**Subject: MHI's Response to US-APWR DCD RAI No.468-3360 Revision 1**

Responses to Request for Additional Information No. 467-3609  
Revision 1

**US-APWR Design Certification**

**RAI NO.:** 468-3360 REVISION 1  
**SRP SECTION:** 09.05.04 – Emergency Diesel Engine Fuel Oil Storage and Transfer System  
**APPLICATION SECTION:** TIER 2 9.5.4  
**DATE OF RAI ISSUE:** 10/6/2009

FIGURE 9.5.4-1 GAS TURBINE GENERATOR FUEL OIL STORAGE AND TRANSFER SYSTEM SCHEMATIC DIAGRAM.

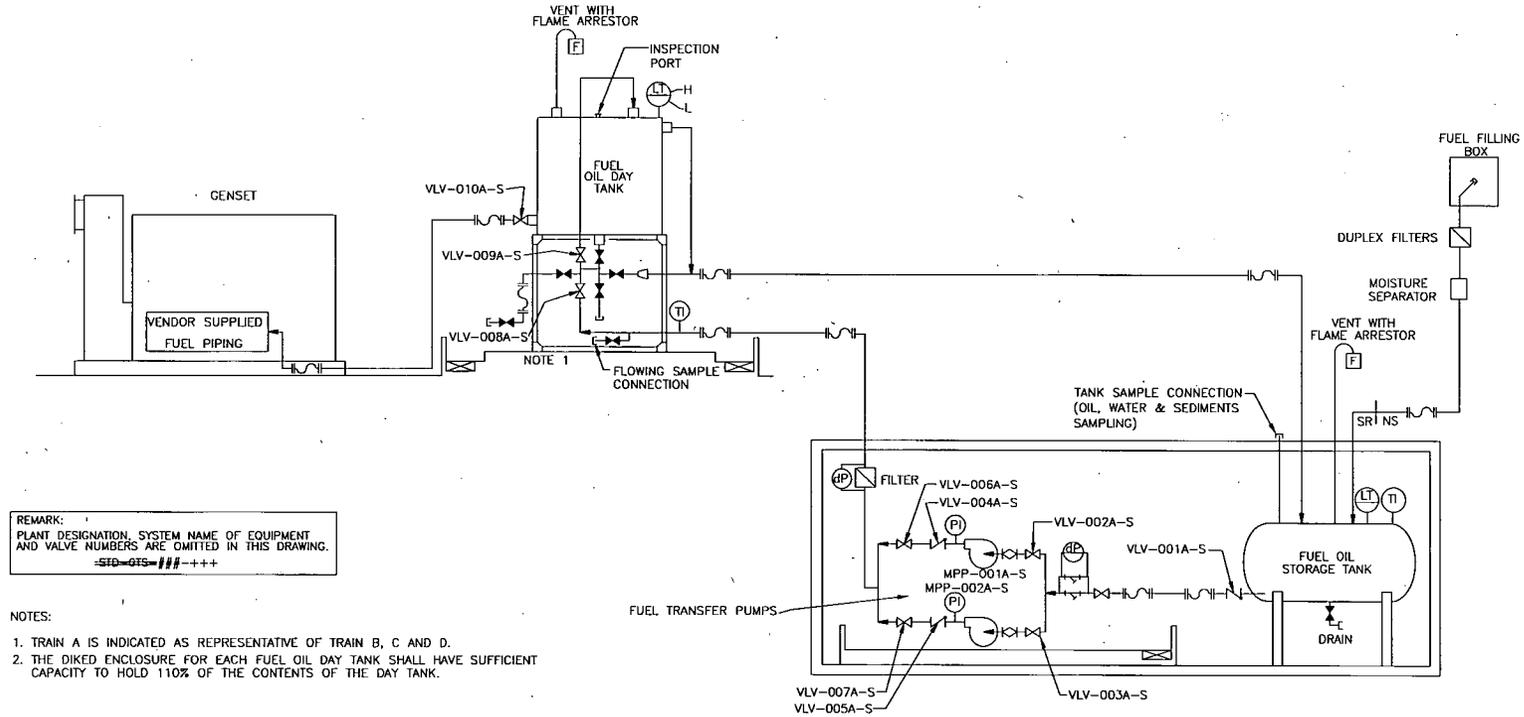
- Section 6.2.4 – The response (top of page 9.5.4-16) states that “fill and sample connections are located at grade elevation...”. However the revised Figure 9.5.4-1 shows the sample connection within the tank enclosure. Revise the response or figure to be consistent. Also, the 6.2.5 response states that “The fill line is above grade.”

- Section 6.3.3.1 – The response notes that “pressure indicators and a differential pressure alarm on the fuel oil transfer pump discharge strainers are provided.” This should refer to the fuel oil transfer pump suction strainers. The response should be revised to be consistent with Figure 9.5.4-1, etc.

**Supplement to Question No. 09.05.04-11 (RAI 9.5.4-06; RAI Set No. SBPB 318-2227, Rev. 1; MHI Ref: UAP-HF-09292, dated 6/9/09):** As noted in the discussion for Question 09.05.04-10, the termination of the sample connection is not consistently described by MHI. In addition, this response states that the sample is from the top of the tank and measures sediment and water. MHI should describe how the sample will be removed against gravity from the top of the tank and explain how a sample from the top will monitor sediment and water, both of which are most likely to be on the bottom of the tank.

**Supplement to Question No. 09.05.04-22 (RAI 9.5.4-17; RAI Set No. SBPB 318-2227 Rev. 1; MHI Ref: UAP-HF-09292, dated 6/9/09):** While the NRC recognizes that Figure 9.5.4-1 is a schematic diagram, the revised drawing clearly indicates that the pump suction connection on the tank is at the top of the tank and extends down internally from the top of the tank to the bottom of the tank. This diagram leaves in question the means of ensuring a flooded suction for the pumps. The check valve shown on the revised figure may maintain a flooded suction once the suction line is filled, but check valves can leak and create an air gap that could prevent the oil transfer function. The design should provide assurance that adequate suction pressure will be maintained.

**Supplement to Question No. 09.05.04-42 (RAI 9.5.4-37; RAI Set No. SBPB 318-2227, Rev.1; MHI Ref: UAP-HF-09292, dated 6/9/09):** While RG 1.189 permits day tanks to be located in the same room as the engine-generator, the acceptance criteria also stipulates that the tank be located within a diked enclosure with 110% capacity or a drain to a safe location. Revised Figure 9.5.4-1 indicates a curb, but does not state that the curb will hold 110% of the day tank volume or that the curbed area is drained to a safe location. The DCD should be revised to state how the spill containment design conforms to the guidance in RG 1.189.

See attached markup for revision to Figure 9.5.4-1 (Attachment A). DCD Section 9.5.4.2.2.1, revised with new paragraphs added after the third paragraph, as revised per Question 44 "Impact on DCD".

Figure 9.5.4-1 is a sketch, not meant to show the actual elevations of the equipment; however this figure is being revised for clarity as shown in the attached drawing. As addressed in RAI No. 09.05.04-08, these pumps are located in the storage tank vault, below the tank outlet, and are therefore able to operate with flooded suction.

The fuel oil transfer pumps are located in the fuel oil storage tanks vaults, as shown in the updated Figure 9.5.4-1, such that sufficient net positive suction head is available under all design conditions, including pump runout. The available NPSH is calculated based on all pump design operating conditions and is incorporated as part of the oil transfer pumps specifications to provide assurance from the pump vendor to properly design and fabricate the oil transfer pumps for their intended purpose. Once a vendor has been selected, the specific parameters for the pumps, including available NPSH, will be confirmed based on vendor documents.

Figure 9.5.4-1 will be revised to indicate that the pump suction connection is at the side of the tank at 6 inches from the tank bottom per DCD Section 9.5.4.2.2 this will assure that adequate suction pressure will be maintained.

Figure 9.5.4-1 will be updated as shown in the attached markup (see Attachment A).

Figure 9.5.4-1 will be updated as shown in the attached markup (see Attachment A).
